# UNITED STATES PATENT AND TRADEMARK OFFICE

APPLICATION NO.	FILING DATE	FIRST NAMED INVENTOR	ATTORNEY DOCKET NO.	CONFIRMATION NO.
10/525,650	02/24/2005	Norbert Schrufer	SCHRUFER 1 PCT	8471
25889	7590	04/17/2009		
COLLARD & ROE, P.C. 1077 NORTHERN BOULEVARD ROSLYN, NY 11576			EXAMINER KRAUSE, JUSTIN MITCHELL	
			ART UNIT 3656	PAPER NUMBER
			MAIL DATE 04/17/2009	DELIVERY MODE PAPER

<b>Office Action Summary</b>	<b>Application No.</b> 10/525,650	<b>Applicant(s)</b> SCHRUFER, NORBERT	
	<b>Examiner</b> JUSTIN KRAUSE	<b>Art Unit</b> 3656

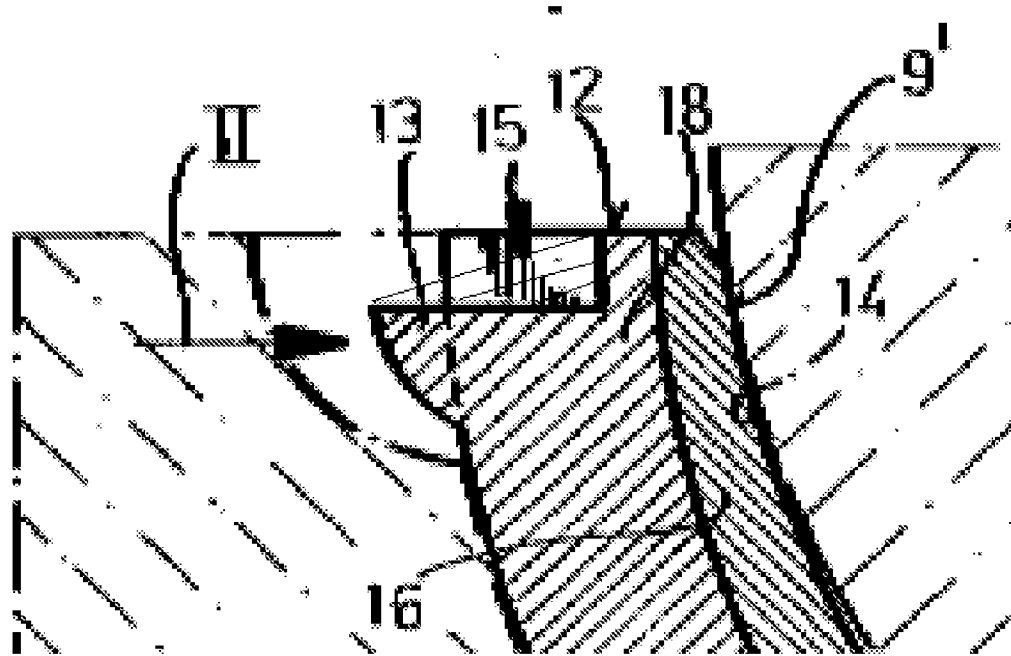
Roemer discloses a sliding bearing shell comprising a shell body (10) having a shell body thickness, a shell back portion (11), a separation area (15), and at least one holding cam (13) arranged near the separation area and projecting radially from the shell back portion, the at least one holding cam forming a deformation section extending over only a part of the shell thickness (see fig 1), wherein the deformation

section comprises a tongue that is partly cut and bent out at an angle (90 degrees is an acceptable angle) from the shell body leaving an indentation starting from the separation area (the indentation is regarded as the depression below the top surface of the bearing surface 12), the indentation having a width measured from the shell body to a side of the tongue facing the shell body that narrows from the separation area (as is illustrated in the figure below by the lines connecting the side of the tongue facing the shell body to the shell body). Regarding the limitation that the tongue is partly cut and bent out from the shell body, the limitation is considered a product by process limitation, and the device satisfies the structure as claimed.
